## **DEVIATION REQUEST AND DECISION FORM**

Project Name : SF227: The Ridge at Lorson Ranch Filing 3

PCD File No. DEV263

A deviation from the standards of or in Section **El Paso County Standard Drawing of the Engineering Criteria Manual (ECM) Detail SD 4-20**, is requested.

Exhibit showing Chemical  
Grout Locations on The Ridge  
at Lorson Ranch Filing 3

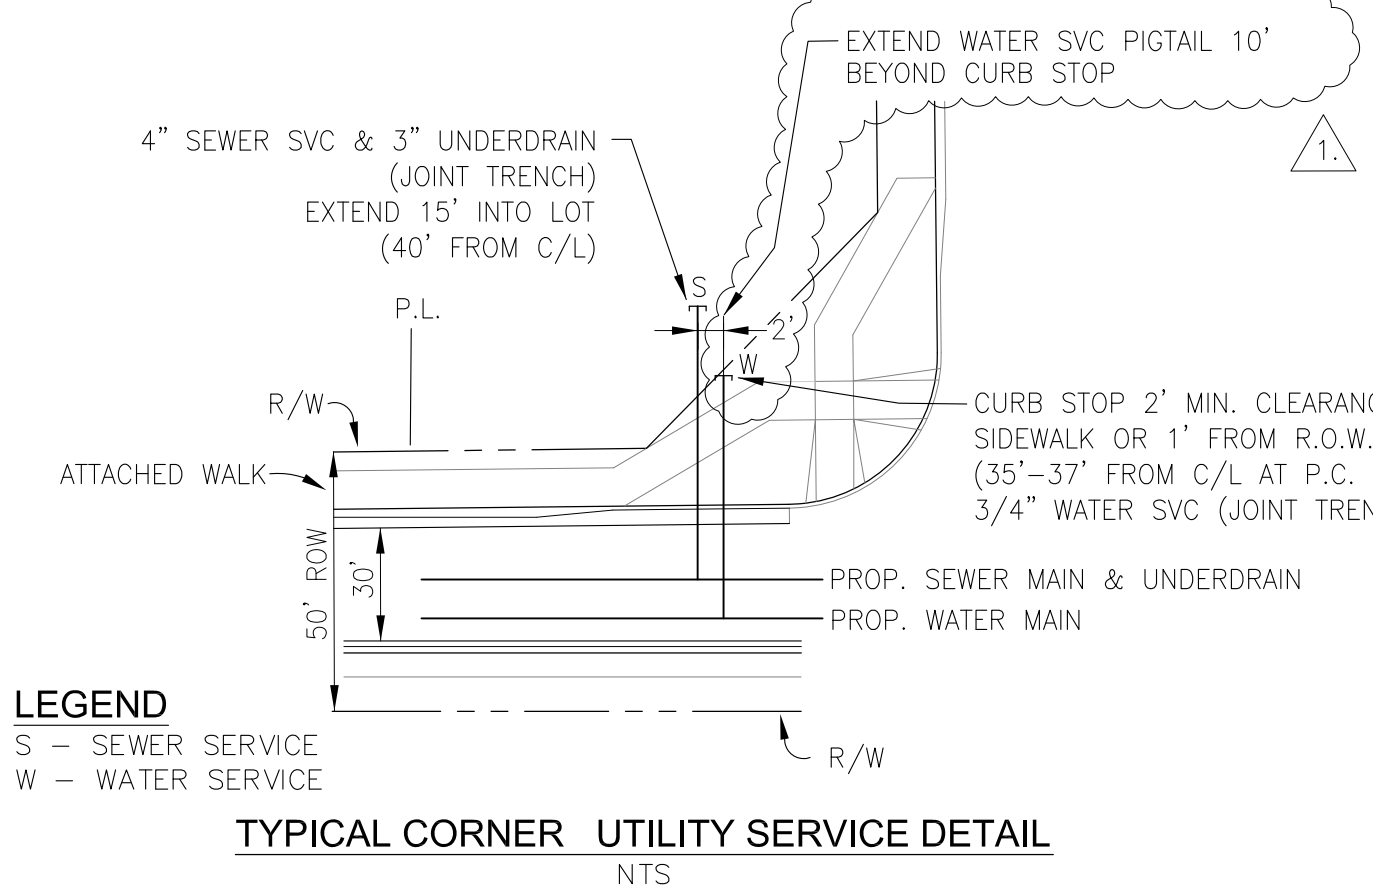
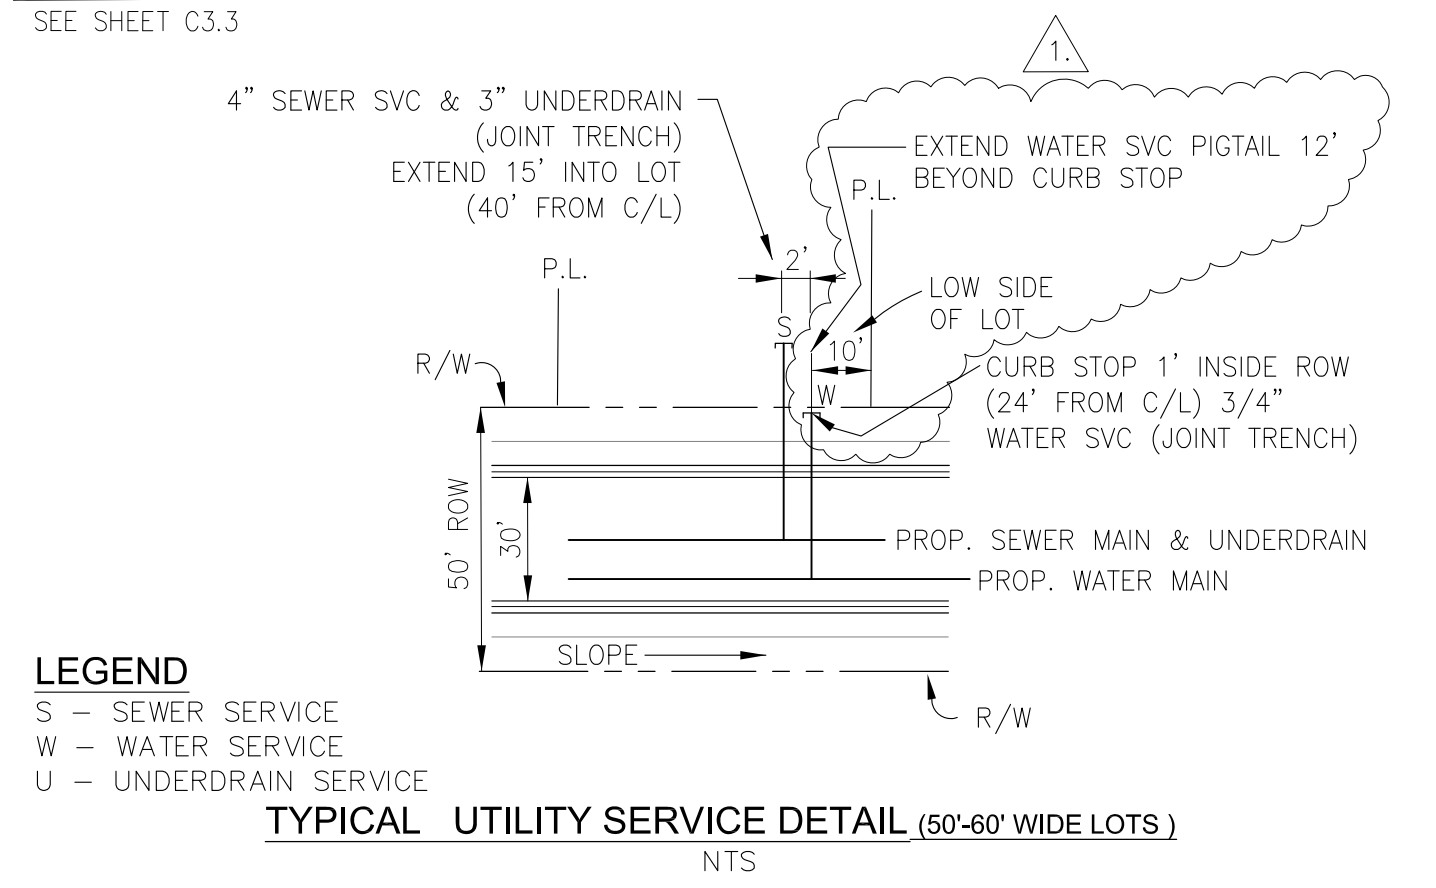
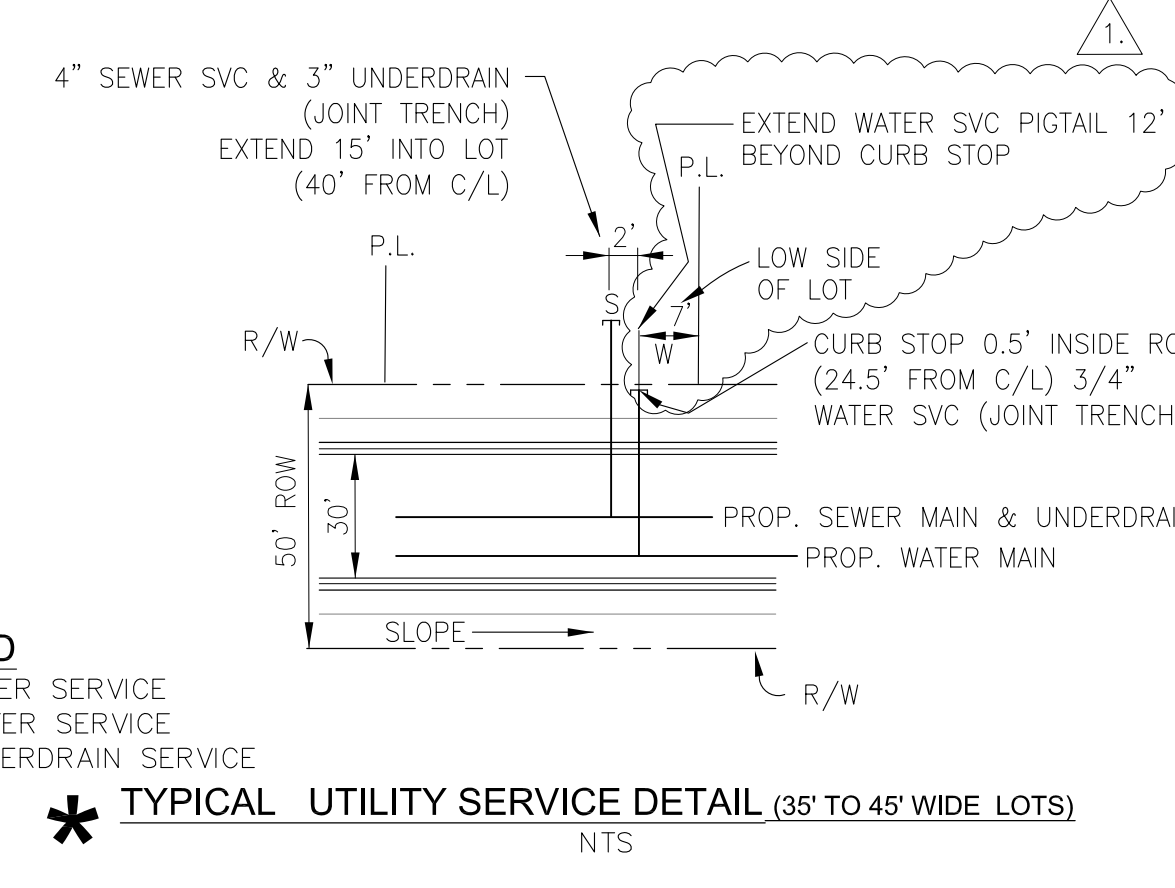
Deviation request for the use of the chemical grout to stabilize the soils within the roadway and utility trenches where settlement and distress were observed and to lift and relevel pavement, concrete flatwork, and stormwater catch basins. The deviation request is requested for The Ridge at Lorson Ranch Filing 3 (File# SF227)

● Minimum 1/2" pavement deflection - area to be treated with chemical grout

The chemical grout should initially be injected approximately 4 feet on center within the utility trenches through a 1/2" injection rod advanced to a depth no greater than 4 feet below land surface (bls) through 5/8" diameter drilled holes. After an initial stabilizing injection volume that will be determined on a case-by-case basis, the injection rod tip will be raised to approximately 1.5' to 2' bls or within 0' to 1' ft bls of the base of the cement-treated subgrade (CTS) to lift and relevel the concrete slabs or pavement. When being utilized to relevel installed stormwater vaults, concrete sidewalks, or concrete curbs, the material will be injected directly beneath the concrete. The elevations of the pavement/slabs should be monitored continuously during the chemical grouting process.
